Subject: Response to Request for Additional Information for the Model No. 8-120B Package, Docket No. 71-9168

Summary of Changes, 8-120B Consolidated SAR, Revision 6

Responses to Request for Additional Information

Figure 1 – Vent Port Test Configuration

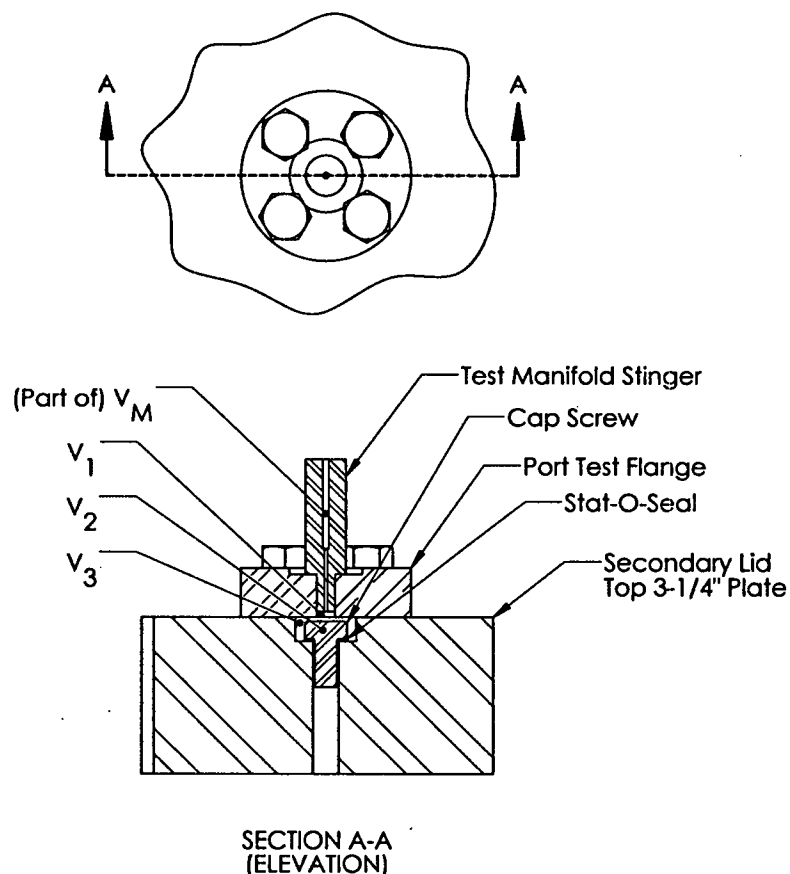
In connection with this notification, we need you to (i) provide complete calculations for the test vent port volume used in the pressure drop test, (ii) clarify the volume (combined test manifold and small residual volume inside the vent port, or small residual volume inside the vent port) that is less than 34.4 cm^3 , and (iii) also clarify if the value of 34.4 cm^3 is correct.

*Your notification states the following: "The vent port test volume (the staff interprets this to be the total of the test vent port volume and test manifold volume) is equal to the combined volume of the test manifold (10 cm^3) plus a very small residual volume inside the vent port (the staff interprets this to be the test vent port volume), which is less than 34.4 cm^3 ." However, you do not specifically state the value of the small residual volume inside the vent port or show how it was calculated. The calculation of the test vent port volume used in the pressure drop test is necessary to show that the test vent port volume in addition to the maximum test manifold volume (10 cm^3) is less than one third of the total of the primary containment seal test chamber volume and the maximum test manifold volume ($20 \text{ min} / 60 \text{ min} * (103.2 \text{ cm}^3 + 10 \text{ cm}^3) = 37.3 \text{ cm}^3$), for the 20 minute hold time to be adequate. The staff calculated that the test vent port volume must be less than $37.3 \text{ cm}^3 - 10 \text{ cm}^3 = 27.3 \text{ cm}^3$ for the 20 minute hold time to be adequate.*

Figure 1 shows the test manifold configuration used for the assembly verification leak test of the 8-120B vent port evaluated in Section 4.4 of the July, 2012 SAR Addendum. The vent port test flange is affixed to the lid, and the test manifold (partially shown in Figure 1) is screwed into the test flange. The volume of the test manifold, V_M , is required to be less than 10 cm^3 .

The total vent port test volume equals $V_M + V_1 + V_2 - V_3$, where V_1 is the small volume inside the $\text{Ø}3/8$ " threaded hole of the test port flange between the bottom end of the test manifold and the top plane of the lid, V_2 is the volume of the $\text{Ø}1.25$ " x $3/8$ " deep countersunk hole in the lid

(sans bolt), and V_3 is the conservative lower bound estimate of volume of the vent port plug, i.e., the $\frac{1}{2}$ " hex cap screw head volume (calculated as a $\varnothing 3/4$ " x $5/16$ " high.) The volume of the vent plug Stat-O-Seal is conservatively neglected.

$$V_1 = 1/8 \text{ in} * \pi/4 * (3/8 \text{ in})^2 * (2.54 \text{ cm/in})^3 = 0.23 \text{ cm}^3$$

$$V_2 = 3/8 \text{ in} * \pi/4 * (1.25 \text{ in})^2 * (2.54 \text{ cm/in})^3 = 7.54 \text{ cm}^3$$

$$V_3 \approx 5/16 \text{ in} * \pi/4 * (3/4 \text{ in})^2 * (2.54 \text{ cm/in})^3 = 2.26 \text{ cm}^3$$

Therefore, the total vent port test volume, including the test manifold volume, is calculated to be 15.5 cm^3 (i.e., $10 + 0.23 + 7.54 - 2.26$), which is much less than the 37.3 cm^3 limit calculated by the NRC staff. The lower vent port test volume limit of 34.4 cm^3 given in the referenced notification was based on a calculation that conservatively neglected the 10 cm^3 manifold volume. With the inclusion of the test manifold volume, we concur with the NRC staff's calculated vent port test volume limit of 37.3 cm^3 for the 20-minute hold time to be adequate.
